# Access Compliance Report

## Public Rights-of-Way

Intersection ID: 3030	Main Street: AMBER_GLEN_DR	Cross Street: JASPAR_CREST_LN	Location:	W
ADA ID: 34F1C18B0D6E	Ramp Type: Perp	Initial Pass/Fail: Fail	Overall Compliance: No	Severity Score: 35

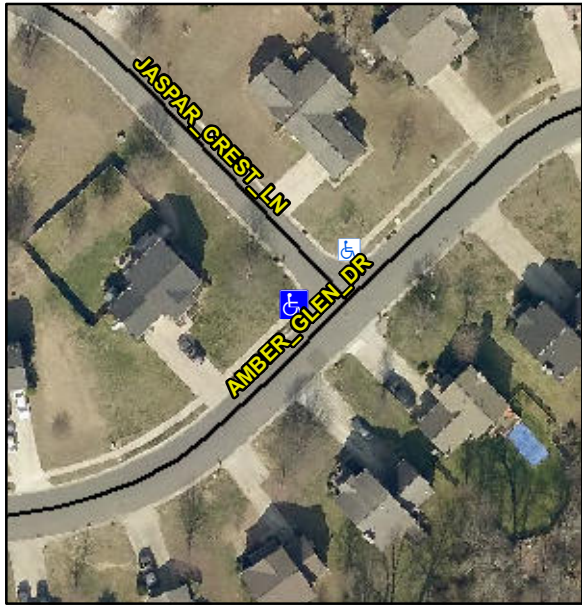
Codes/Mitigation Info/Possible Solution			Field Measurements/Component Compliance					
	Possible Solutions:		Compliance	Description	Data	Compliance	Description	Data
	Remove & Replace Entire Ramp.		N/A	Ramp Length (in)	47.0	Yes	Ramp Slope (%)	5.0
			No	Ramp Width (in)	31.0	Yes	Ramp XSlope (%)	0.3
			N/A	Flare Type LT	N/A	N/A	Flare Type RT	N/A
			N/A	Flare Slope LT (%)	N/A	N/A	Flare Slope RT (%)	N/A
			N/A	Flare Traversable LT?	N/A	N/A	Flare Traversable RT?	N/A
			N/A	Landing Length (in)	N/A	N/A	DWS Provided?	N/A
			N/A	Landing Width (in)	N/A	N/A	DWS Contrast?	N/A
			N/A	Landing Slope (%)	N/A	N/A	DWS Length (in)	N/A
			N/A	Landing X Slope (%)	N/A	N/A	DWS Full Width?	N/A
Surveyor Notes:			N/A	Landing Curb? (Y/N)	N/A	N/A	DWS Offset (in)	N/A
PROW/ADA:			N/A	Shared Landing?	N/A			
Not Found, R304.5.1			N/A	Gutter Ponding?	N/A	N/A	Gutter Slope (%)	N/A
			N/A	Gutter Lip Ht (in)	N/A	N/A	Gutter X Slope (%)	N/A
			N/A	Painted X Walk1?	No	N/A	Painted X Walk2?	N/A
